ADA Curb Ramp New Construction Inspection Form (Parallel)

Shadybrook

24952.54

Yorkshire

PARALLEL RAMP (PL)

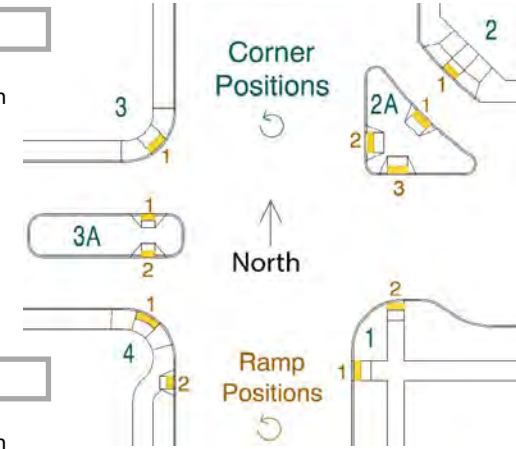
5.4 $\leq 2.0\%$ ☐ $> 2.0\%$ ☒

$\leq 2.0\%$ ☐ $> 2.0\%$ ☒

N Y ☐ N ☒

0.5 $\leq 1/4"$ ☐ $> 1/4"$ ☒

1.6 $\leq |5.0\%|$ ☐ $> |5.0\%|$ ☒

N Y ☐ N ☒

4 $\leq 2.0\%$ ☐ $> 2.0\%$ ☒

5.2 $\leq 2.0\%$ ☐ $> 2.0\%$ ☒

3.65 $\geq 4.0'$ ☐ $< 4.0'$ ☒

5.4 $\leq 2.0\%$ ☐ $> 2.0\%$ ☒

CRK curb & gutt. No td.
